September 24, 2010

103-89500

**RE: PROJECT NO. 0950137-032-AC  
REQUEST FOR ADDITIONAL INFORMATION (RAI)  
STANTON ENERGY CENTER, UNITS 1 AND 2  
HEAT INPUT INCREASE AND PERMIT MODIFICATIONS**

Figure 1. SEC Unit 1 4-Hr Average Output > 450 MW

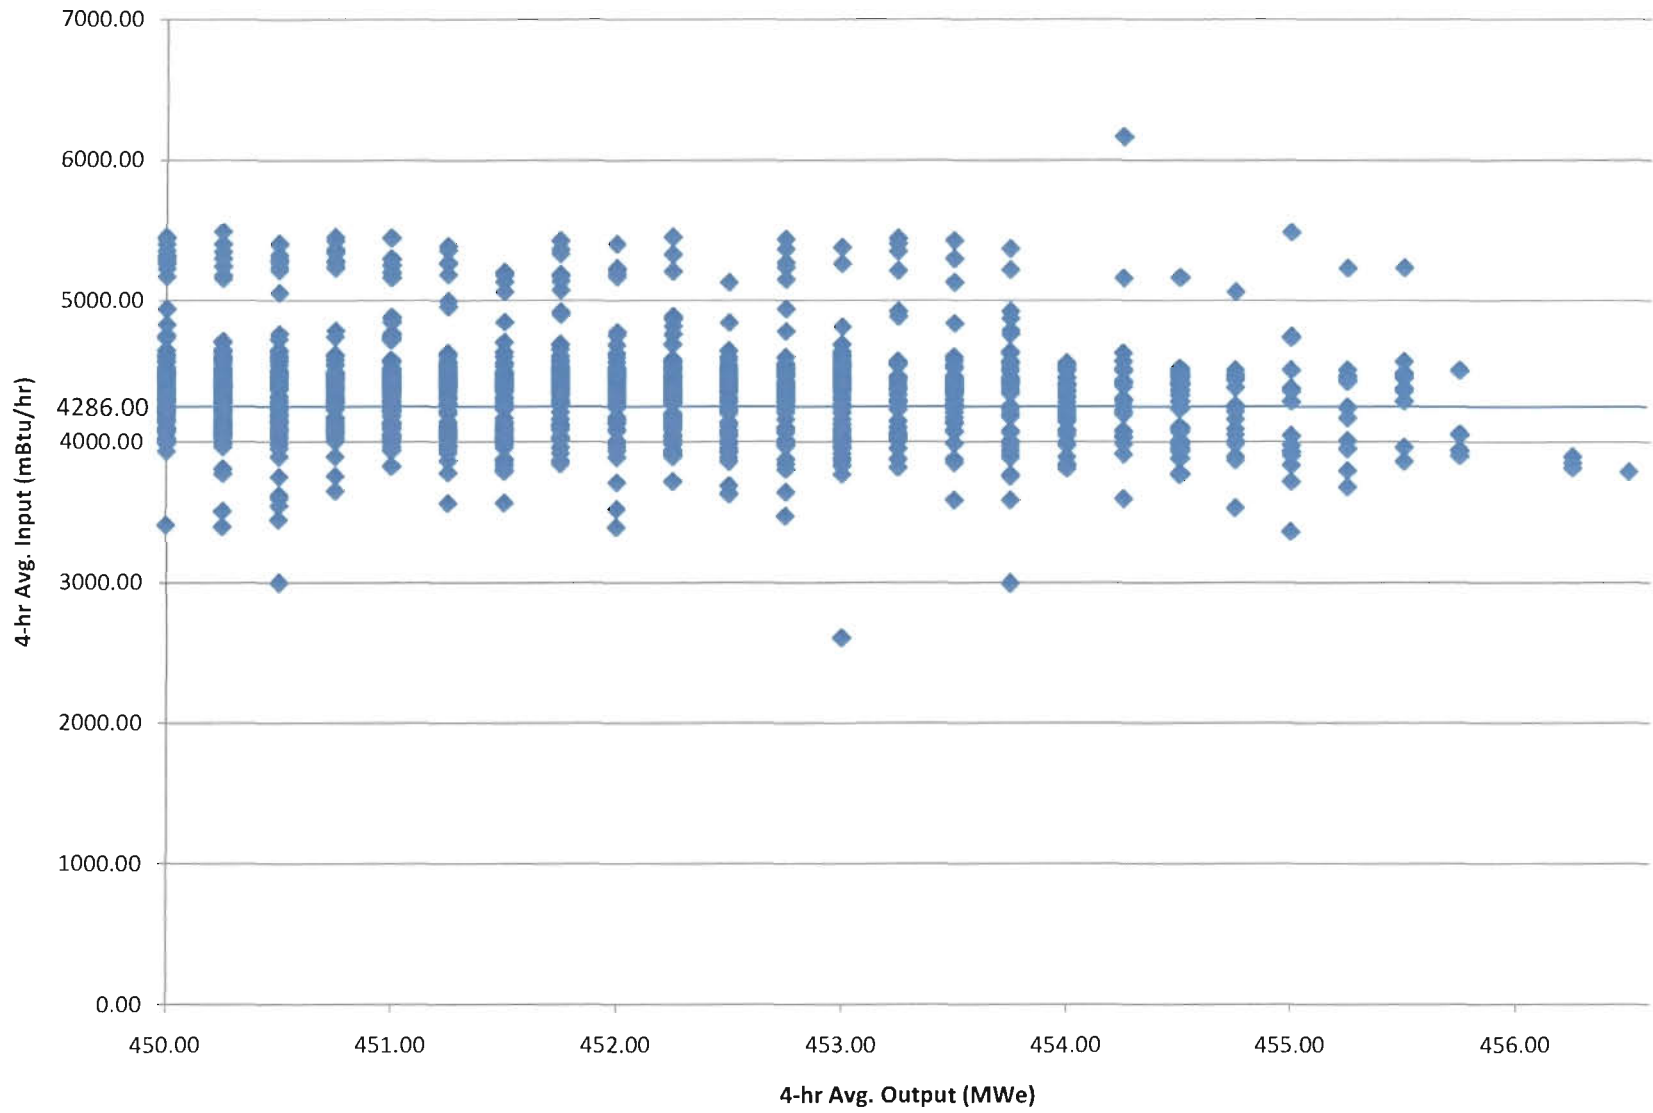
1. *The original heat input limit for Unit 1 was 4,136 mmBtu/hr as part of the original site certification under PA81-14. This limit was increased to 4,286 mmBtu/hr under PSD-FL-084 as well as the limit for Unit 2 was set at 4,286 mmBtu/hr. Both units have been operating under these conditions since 1996. Based upon hourly acid rain data (calendar years 2005-2007)\*, both units demonstrate the ability to operate at 468 MW and within the 4,286 mmBtu/hr limit. However, this information also shows the units operating above the heat input limit and the ability of the units to operate at the higher values. Provide an explanation for the numerous heat input rate excursions when the facility has demonstrated the ability to operate at maximum generating capacity and within the permitted maximum heat input rates. Are there operational changes which could alleviate some of the issues such as coal storage or drying?*

**Response:** The Department is correct that the Acid Rain heat input data show the ability of both units to operate at greater than 450 MW and within the 4,286 mmBtu/hr heat input limit, as well as the ability to operate above the heat input limit and generate approximately the same MW output. In fact, attached are several figures that graphically depict this relationship (Figures 1 and 2, representing Units 1 and 2, respectively).
